LaserBase MF6530
LaserBase MF6540PL
LaserBase MF6550
LaserBase MF6560PL
LaserBase MF6580PL

MF6500-017 Rev. 1
(F9-T01-M00-10035-02)

Point to note for replacing compression spring (rear)

P-1 Transfer unit

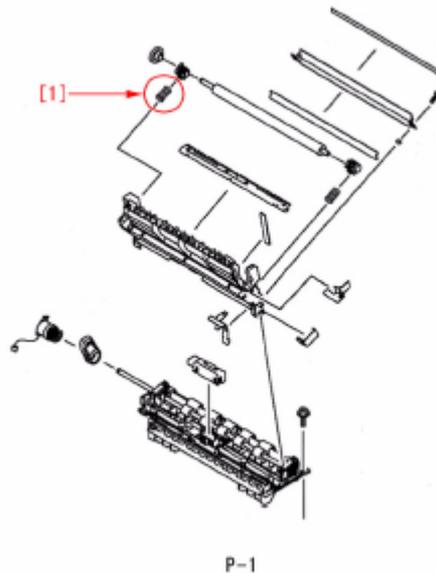
As for the machines listed in “Affected Machines” below, for the purpose of ensuring parallelism of print images, three kinds of springs (i.e., blue, red, and silver) are prepared as the rear compression spring [1] so that a worker can choose one of them according to their pressure at the time of replacement. In case that the wrong spring is attached, the parallelism of print images may be poor. When replacing the rear compression spring, be sure to use one of the same color as the one the machine has long used. These 3 kinds of rear compression springs will be unified and newly set up as the compression spring set (FM3-2397).

[1] Compression spring (rear)
